**BOROUGH OF LAKE COMO
1740 MAIN STREET
LAKE COMO, NJ 07719**

PLANNING BOARD AGENDA

**Re: Completeness/Technical Review #3
Tonelli Variance Application
1808 Fernwood Road
Block 14, Lot 40
H2M Project No. LKCP 2502**

PROJECT TITLE:
 ADDITION & ALTERATIONS
 TO
 TONELLI RESIDENCE
 1808 FERNWOOD ROAD
 LAKE COMO, NEW JERSEY

O-A

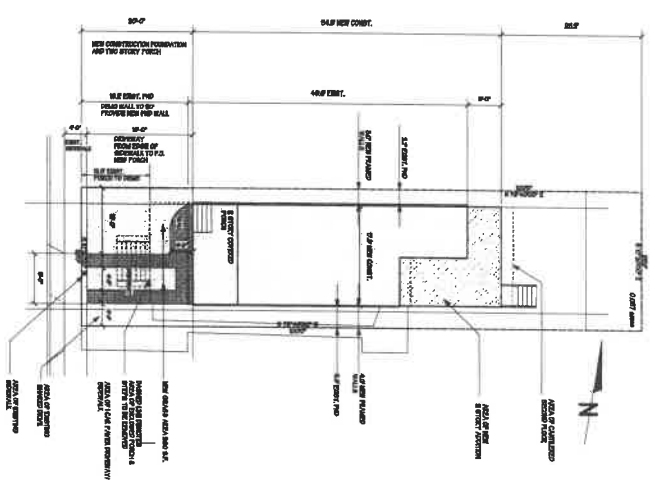
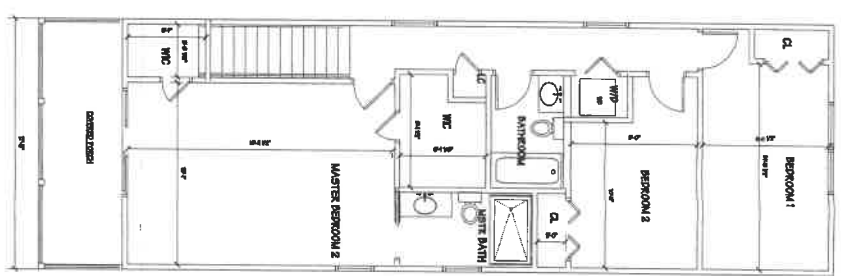
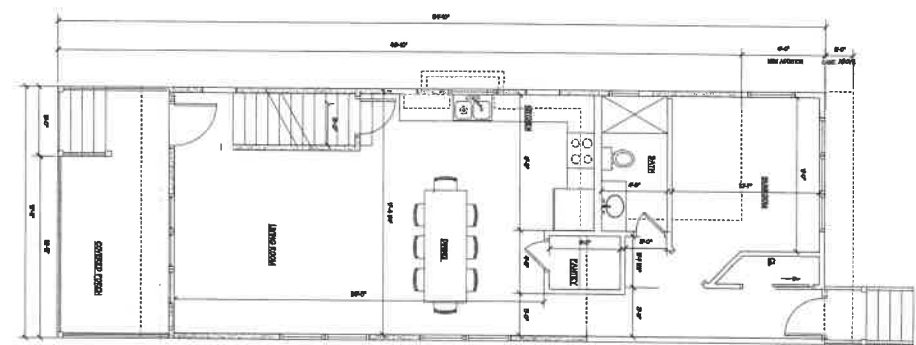
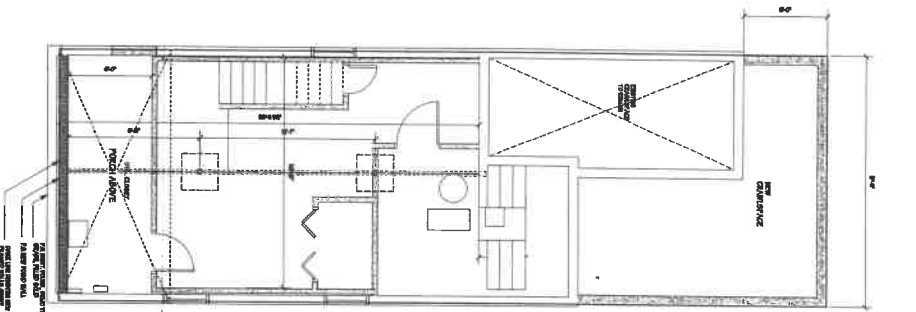
6. The elevation drawings on Sheet A-0 of the Architectural Plans are not to scale, thus the building elevation cannot be confirmed. The Architectural Plans should be revised to be an acceptable scale.

7. The "Building Data" table on Sheet A-0 of the Architectural Plans contains values that do not sum to the reported totals. The "Building Data" table should be revised to reflect the correct existing and proposed conditions.

PLOT/GRADING PLAN FOR #3 RIPLEY LANE

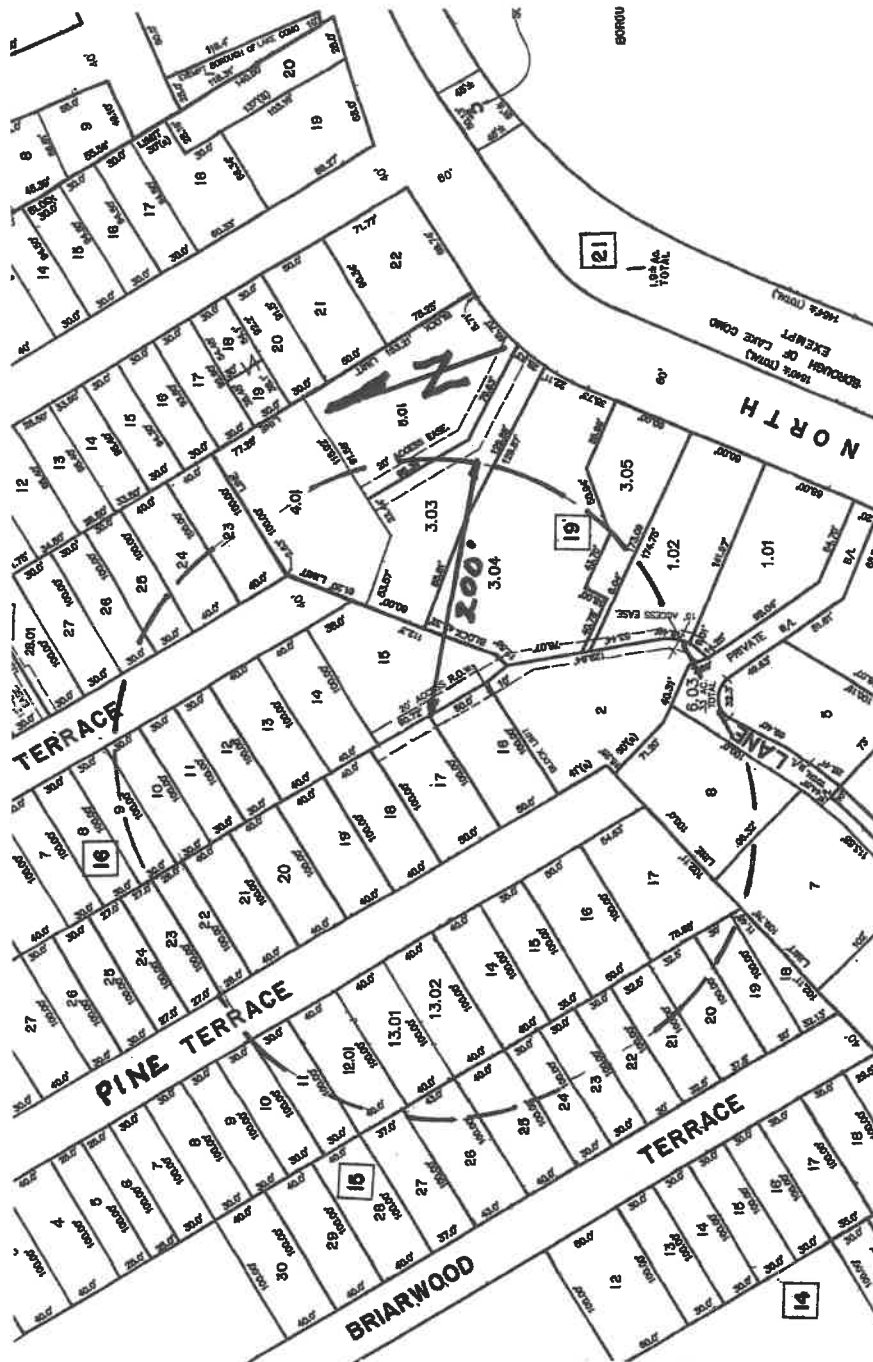
1. Ordinance 2024-01 specifies the requirements for drywells and seepage pits for new structures and additions. A drywell is proposed on the Plot/Grading Plan; however, it appears to be established along the surface of the entire southern boundary shared with Lot 16. Ordinance

2024-01 establishes that drywells must be located 5 feet from any property line and must have a minimum of two feet of cover. Additionally, roof leaders from the proposed pass-through garage and additions, including the enclosed porch. Variances are required for the three (3) identified non-conformities: (1) drywell within 5 ft setback, (2) drywell does not achieve 2ft minimum cover, and (3) roof leaders not included on Plot/Grading Plan.
